Service Bulletin 23

(a) Service Bulletin No.	23
(b) Revision / Date	3 / January 2021
(c) Title:	Lindstrand Jetstream Burner: Inspection / Modification of Toggle Valve Assemblies
(d) Description:	Part 1: Inspection of toggle valve seat carriers for wear at every 100 hour / annual inspection if mod C650 stems are not fitted. Part 2: Replacement of pre-Mod C650 valve stems with Mod C650 fail safe version.
(e) Applicability:	All 'Jetstream' burners and Lindstrand Cloudhopper burners using toggle action valves
(f) Effectivity:	All CN using Jetstream burners and Lindstrand Cloudhoppers

Lindstrand Jetstream Burner: Service Bulletin No. 23

Fig 1: Valve type identification

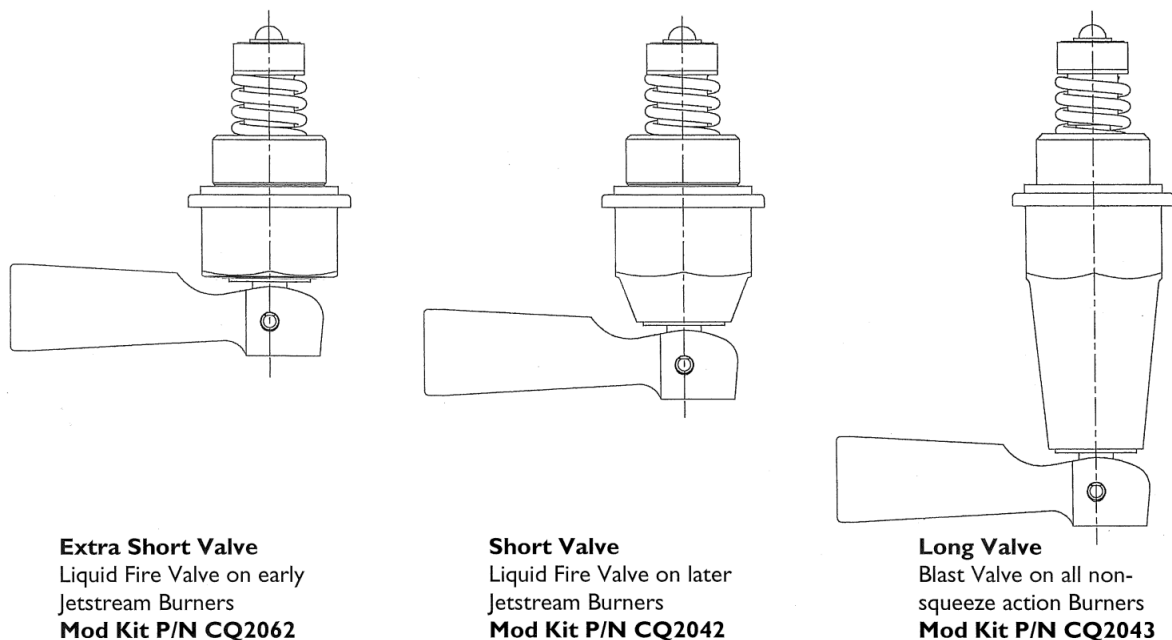
Four different valve configurations exist; the only difference between these valve assemblies is the height of the bonnet and the length of the valve stem. If the valve stems are to be replaced each will require the appropriate seal kit.

Note:
On burners with hydraulic remote control a special type **Long Valve** is fitted. Mod Kit P/N CQ2044

Fig 2: Seat carrier wear step measurement

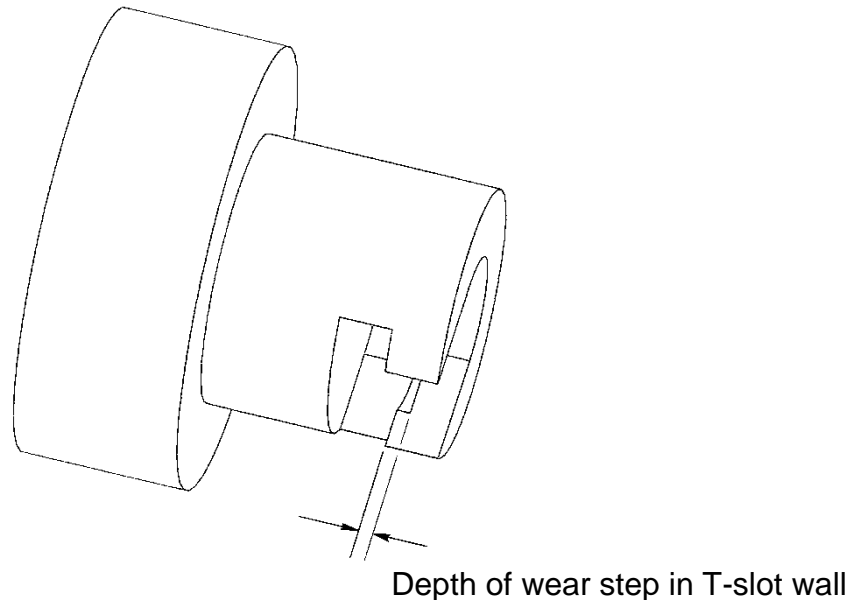
2. Dismantle the valve assembly according to the instructions in the Lindstrand maintenance manual.
3. **Inspect the Seat Carrier for suitability for continued service:** Inspect the T-slot at the back of the seat carrier for any wear step in the side wall of the slot (ref figure 2). If a step is visible measure how deep it is by comparison to a ruler marked in half millimetre divisions, or other suitable method, and record the result on the Service Bulletin confirmation slip. If the wear step is less than 0.2mm then the seat carrier is acceptable for continued service. If the wear step is more than 0.2mm the seat carrier must be replaced
